Request for Bid	 Marshall University Office of Purchasing One John Marshall Drive Huntington, WV 25755-4100 Direct all inquiries regarding this order to: (304) 696-2599	Bid Number R2101645 - Shewey Building Interior Renovations Addendum No. 01
------------------------	---	--

ADDENDUM NO. 1 May 11, 2021

Marshall University – Shewey Building Interior Renovations

Addendum No. 01
Request for Bid
R2101645 – Shewey Building Interior Renovations
Technical Questions and Answers

2 NEW LOCKER PLAN
FIRST FLOOR LOCKER ROOM
A2.2 1/8" = 1'-0"

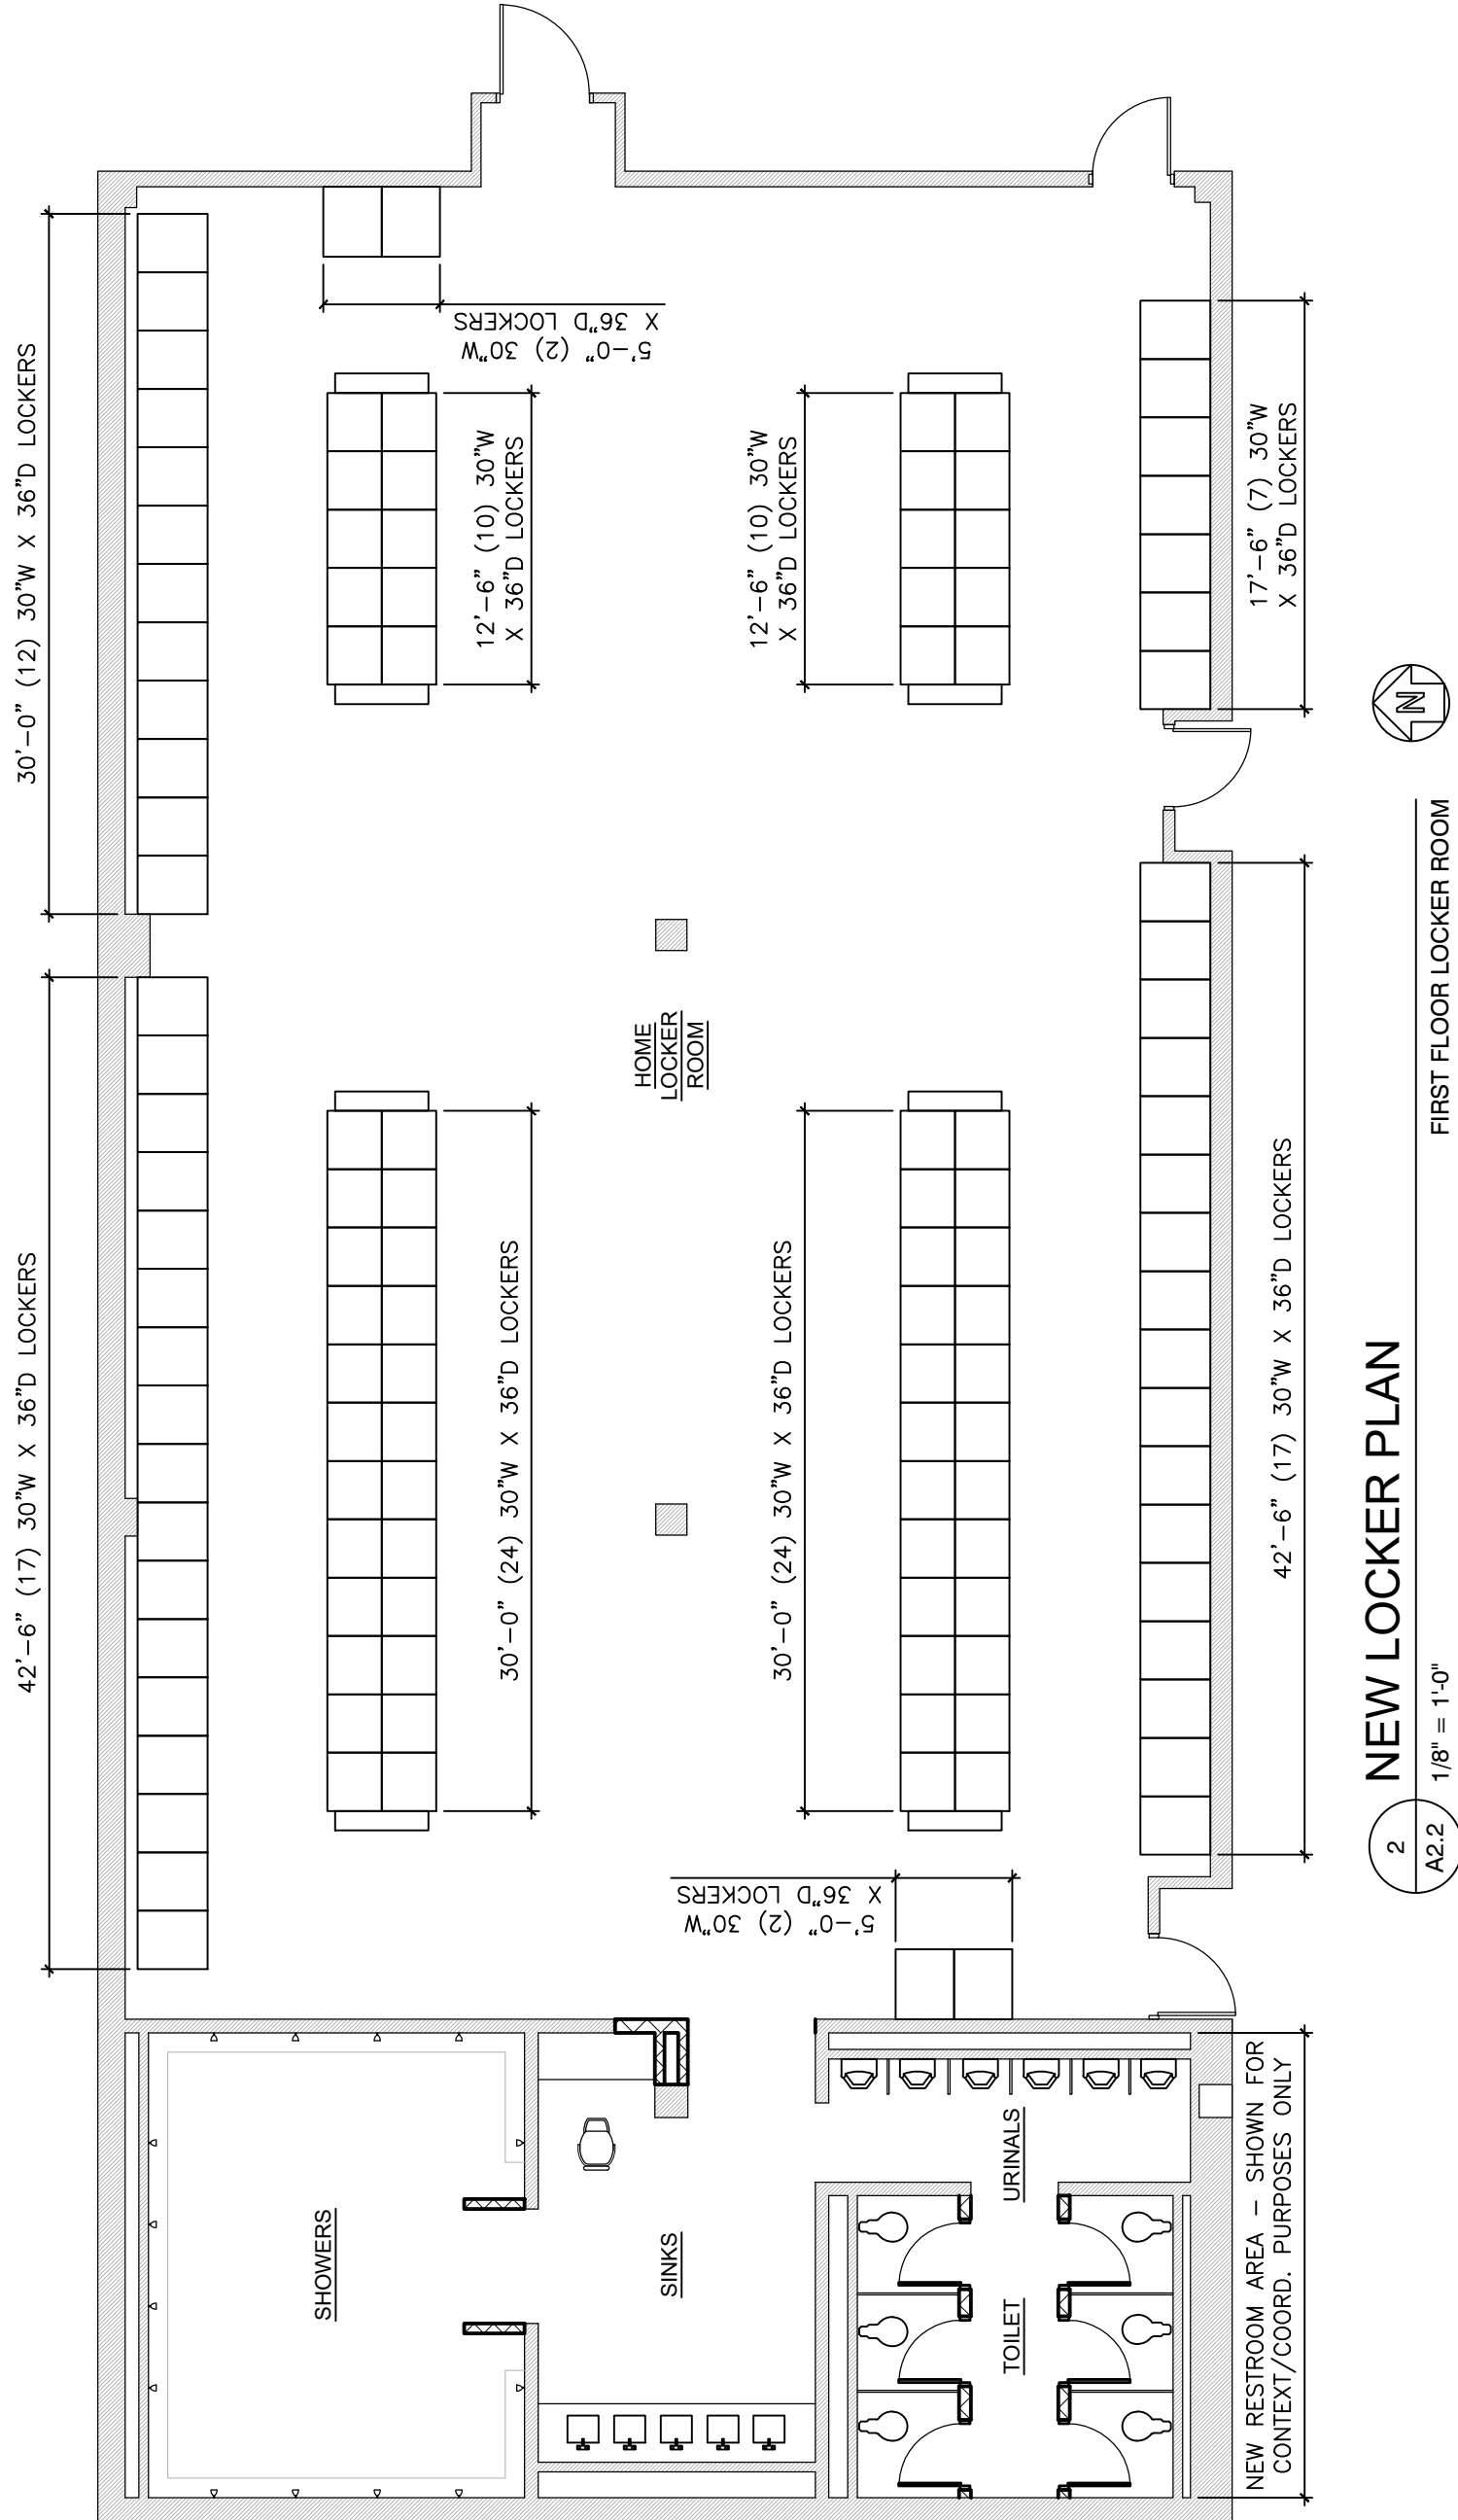
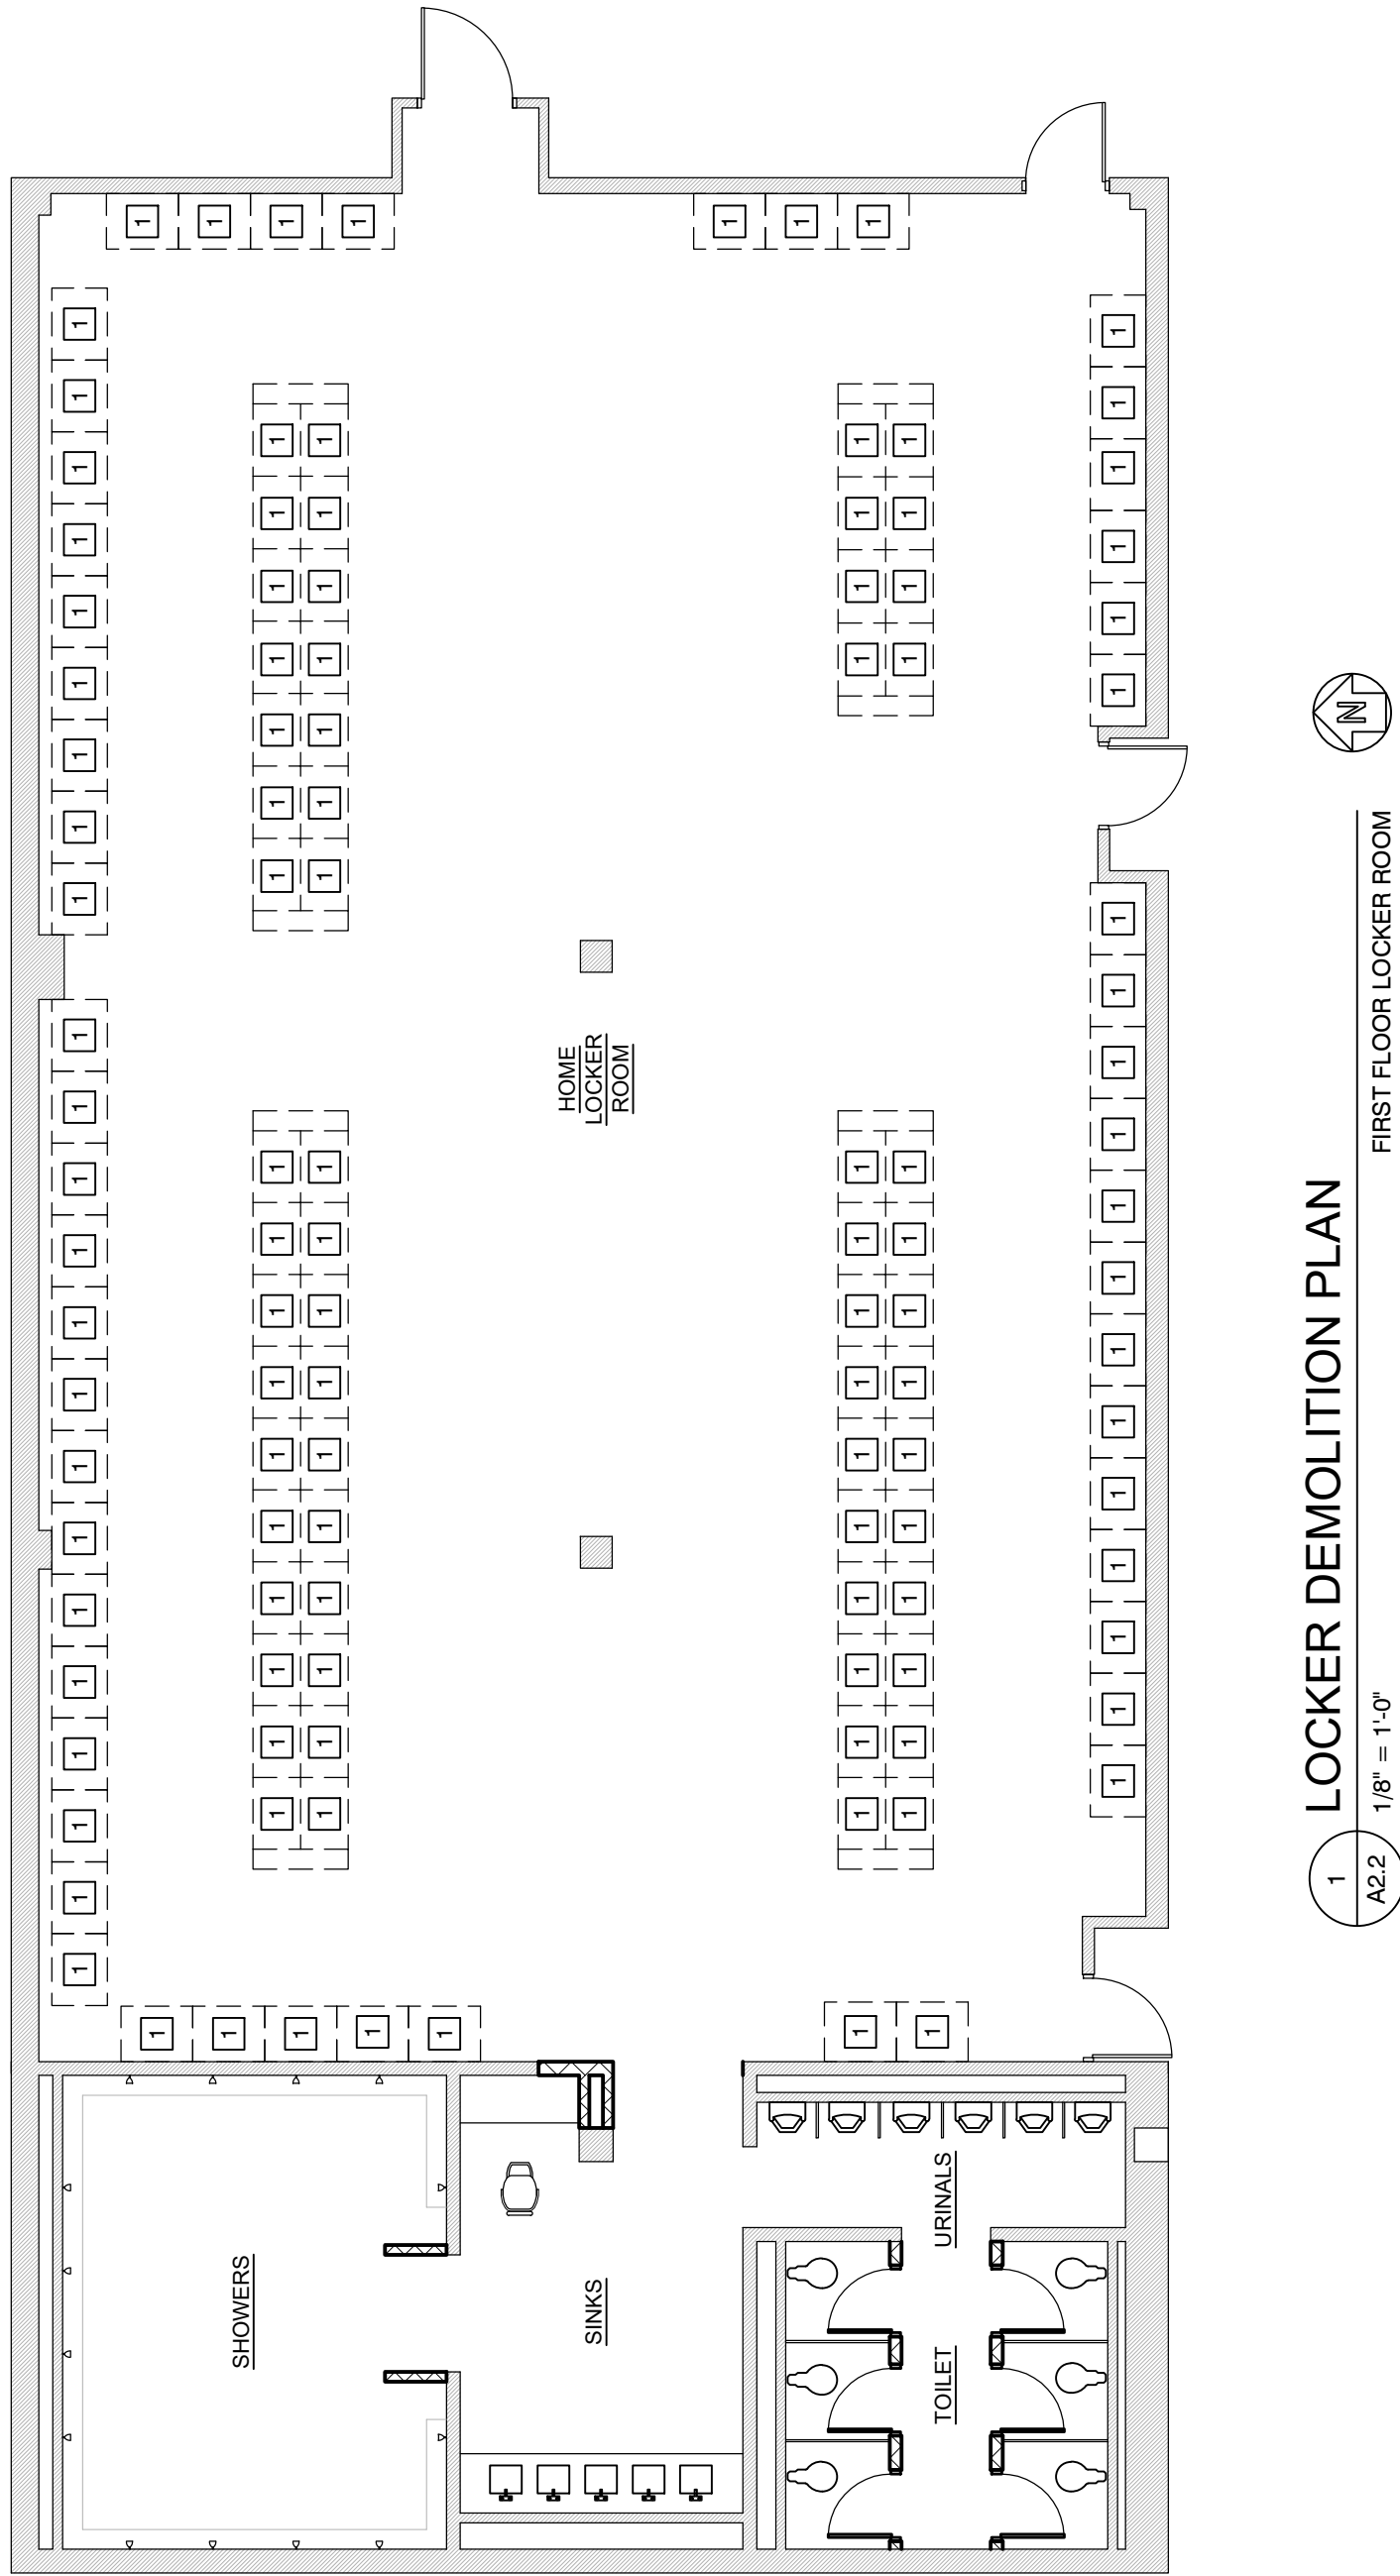
C. New Player Lockers: Include the stipulated sum of \$375,000.00 for purchase, delivery and installation of 125 player lockers (See Drawing A2.2). Locker installation will not be complete by the Final Completion Date of 7/31/2021, so the General Contractor will not be held responsible for delays associated with this portion of the work. Locker installation is scheduled to be completed prior to the first home game (9/11/2021).

SHEWEY BUILDING LOWER LEVEL PLAN

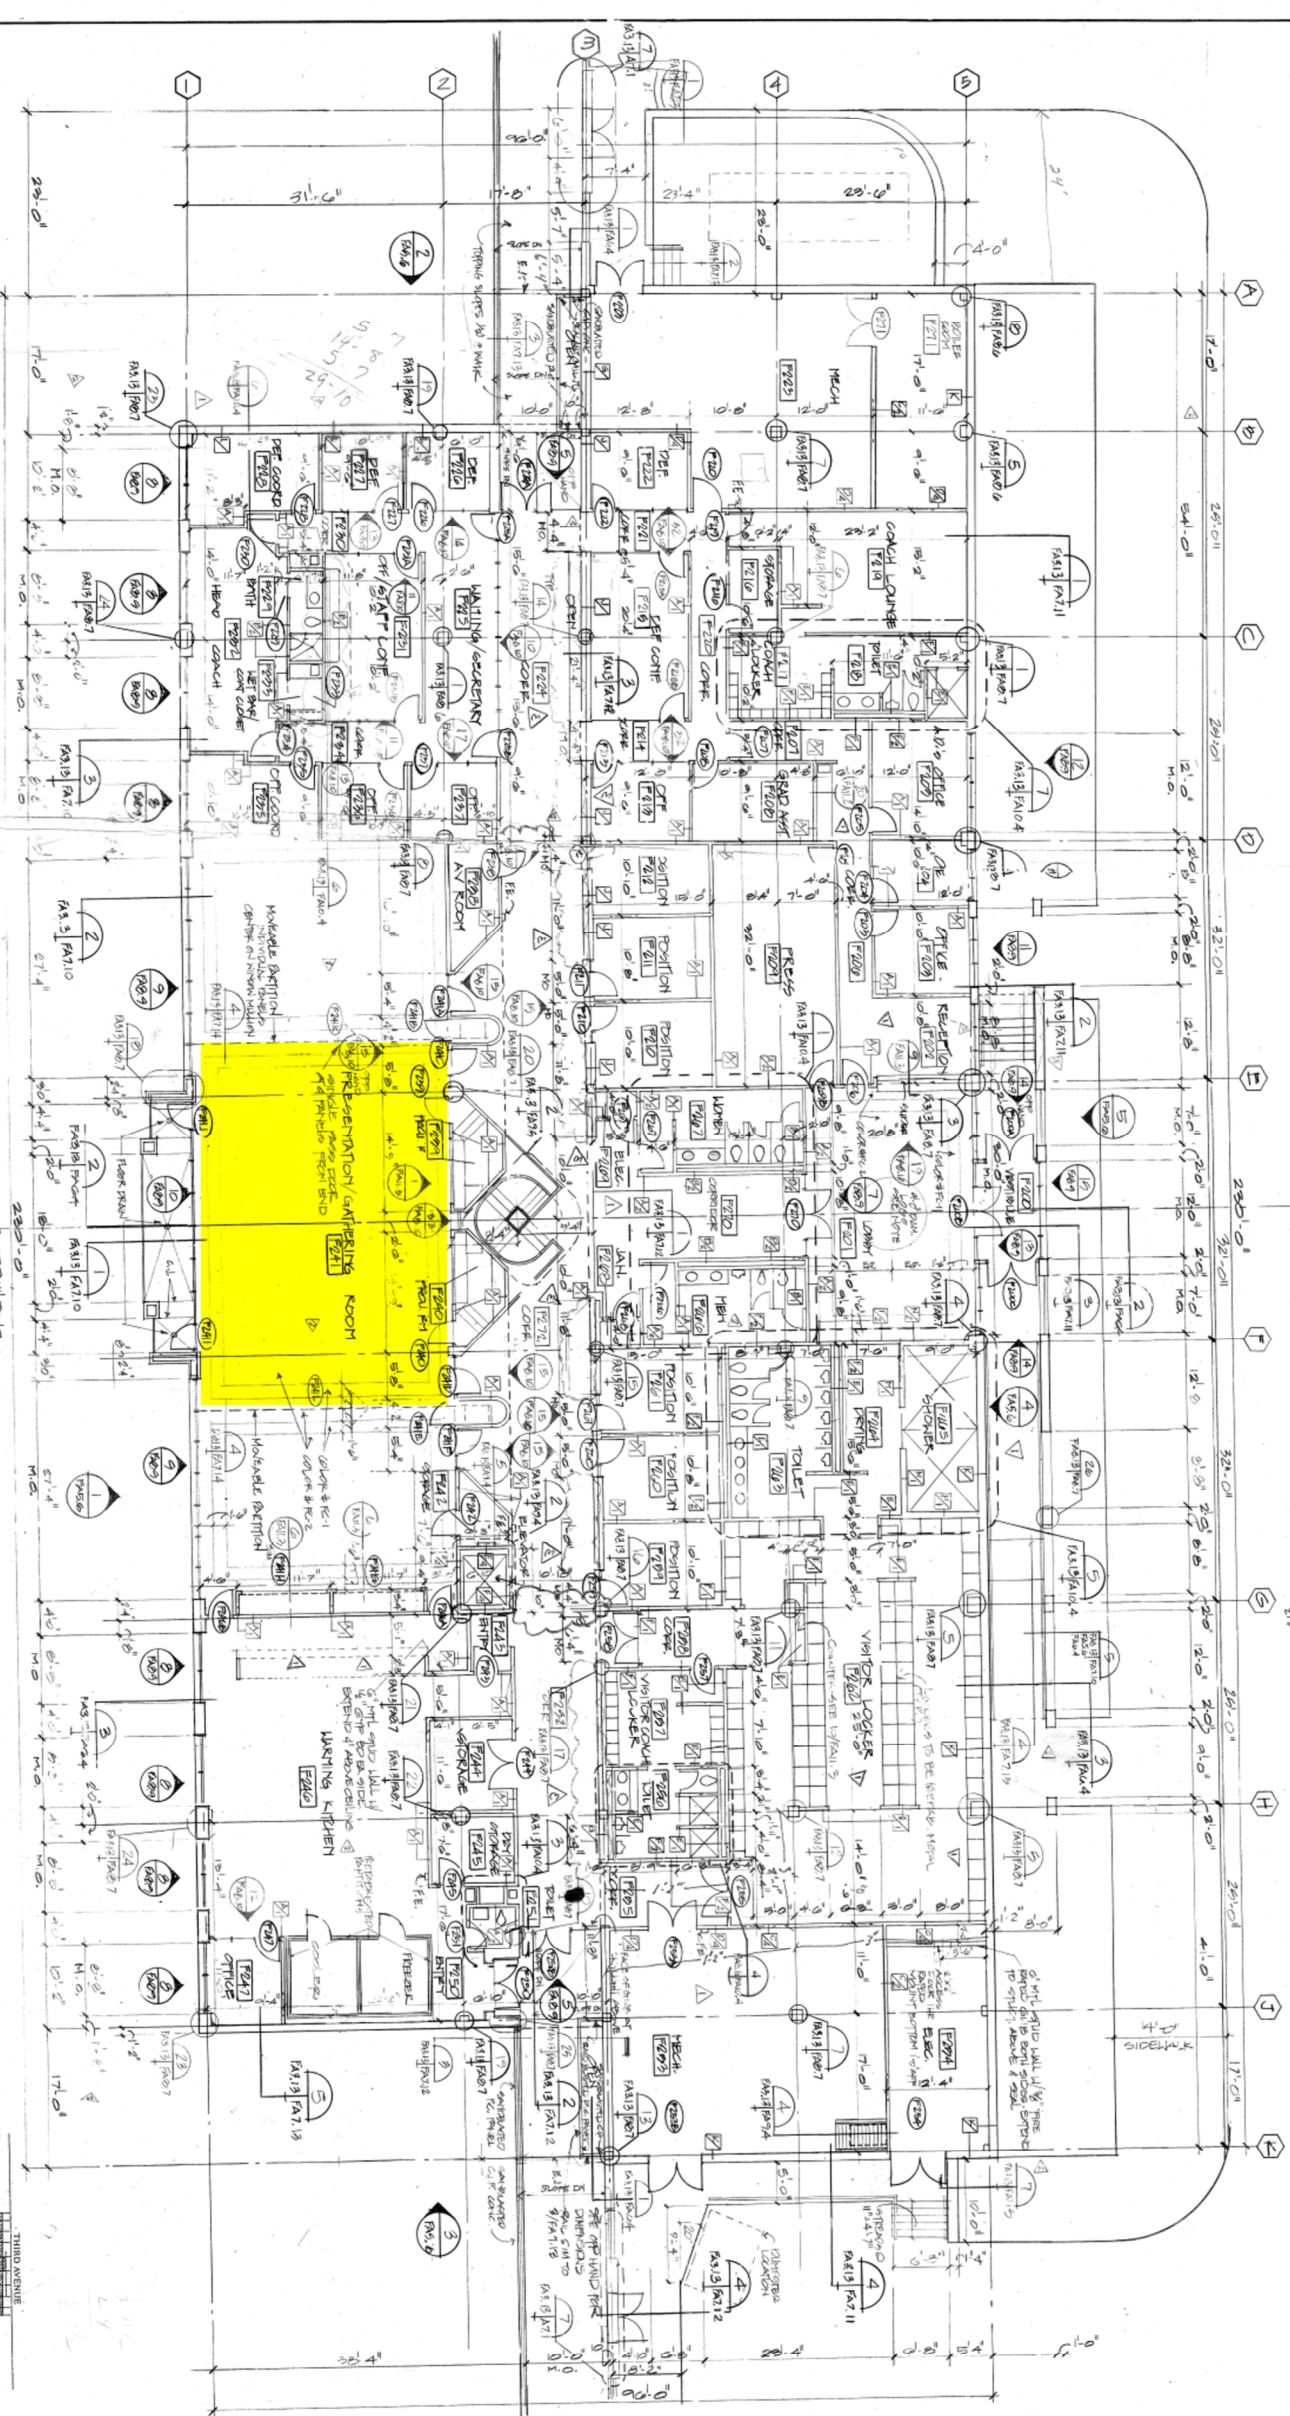
A10. Roof access is provided in Mechanical Room 253 – See Upper Level Plan in Addendum 1.
